**County of Loudoun**  
**Department of Planning**  
**MEMORANDUM**

**SUBJECT: SPEX 2007-0025, Paragon Park - Office**  
**SPEX 2007-0034, Paragon Park - Hotel**

**SUBJECT:** SPEX 2007-0025, Paragon Park – Office, 2<sup>nd</sup> Referral  
SPEX 2007-0034, Paragon Park – Hotel, 2<sup>nd</sup> Referral  
SPEX 2008-0008, Paragon Park – Bank  
SPEX 2008-0009, Paragon Park – Service Station

**Proposed Illustrative**

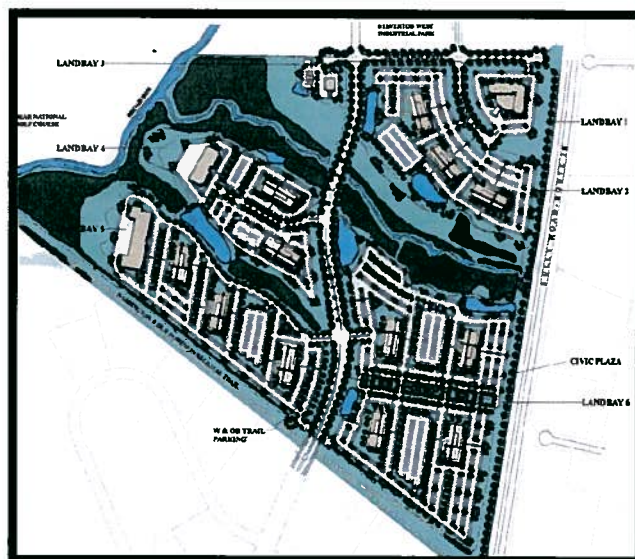
Overall, the applicant proposes office buildings surrounded by surface parking. Because the office uses of a Keynote area are to be prominent features of the community when viewed from periphery roads (Revised General Plan, Guideline 7.a., p. 11-14), the placement of surface parking between the proposed buildings and the periphery roads negates the intent of these guidelines. The applicant has also not committed to the number of stories for each building. Given the site's high visibility along Route 28, tall, high-profile buildings would be appropriate. Relocating the parking behind such buildings, in accordance with Plan policies, would minimize the prominence of the parking lots and create a unified building corridor along Route 28 and Pacific Boulevard. It also appears that the applicant has depicted several parking structures in

Sheet 3 of the plat also indicates that the development will include three bus stops along Pacific Boulevard. The applicant has not, however, committed to bus shelters. Neither has the applicant committed to widened buffers, enhanced plant materials, or pedestrian routes through parking lots, as promoted by Plan policies. Parking could be screened and its visual impact mitigated through the use of walls, hedges, street trees, heavy landscaping, depressed parking areas, and earthen berms. The entryways from Pacific Boulevard could also be enhanced with measures such as enlarged landscape areas, 10-foot wide sidewalks on each side of entry roads, and 5-foot landscape buffers between entry roads and the sidewalks.

**Figure 10**

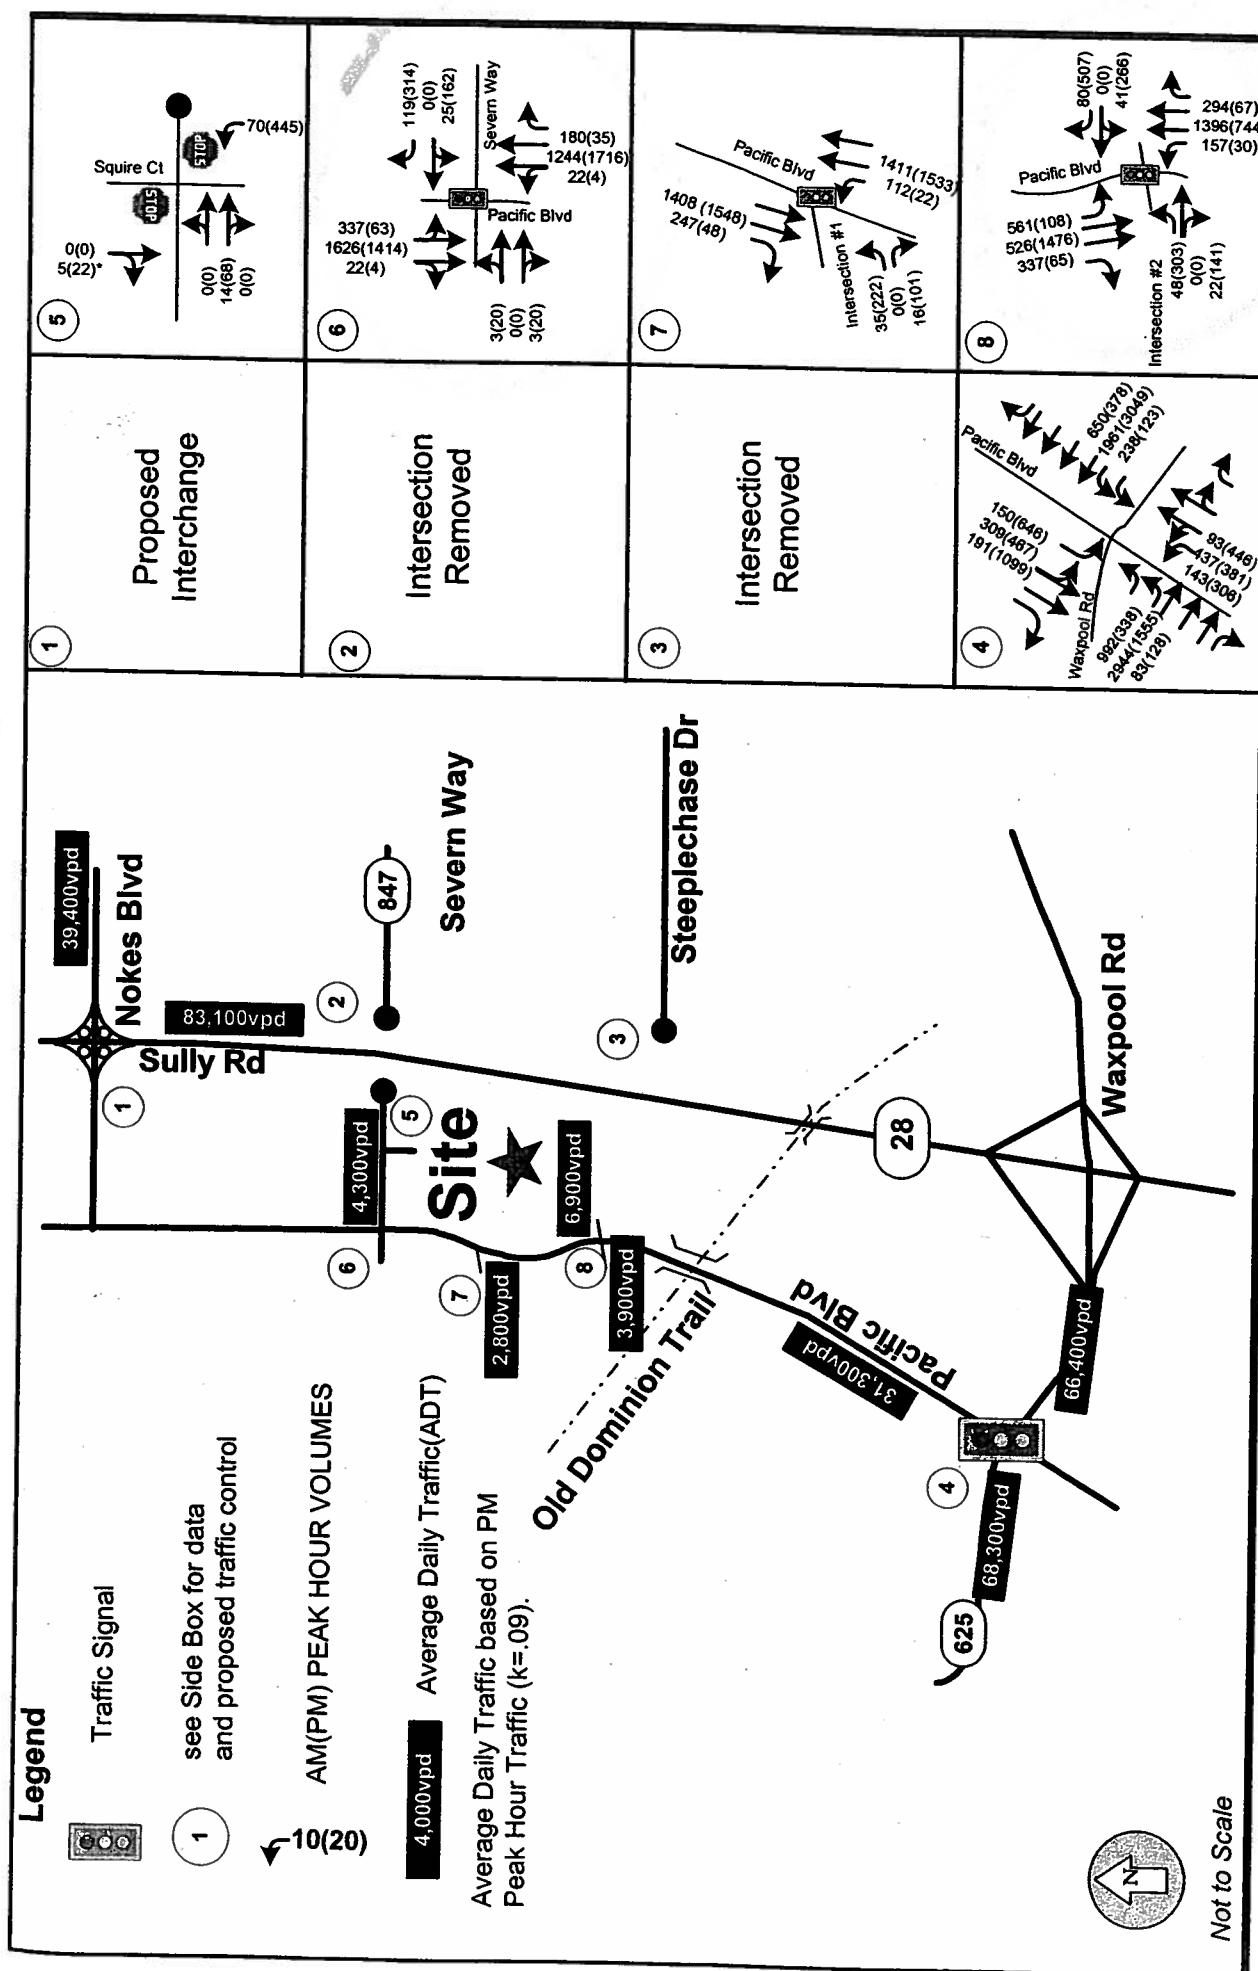
- **Pacific Blvd/Severn Way:** The lane configuration on Figure 10 shows the through and left turn lane is shared. Although the VDOT final design does not show the lane Configuration at this intersection, the traffic study shows there are 337 vehicles that will turn left from Pacific Blvd south to Severn Way. A separate left turn lane is required to accommodate the traffic demand. A signal is required by VDOT.
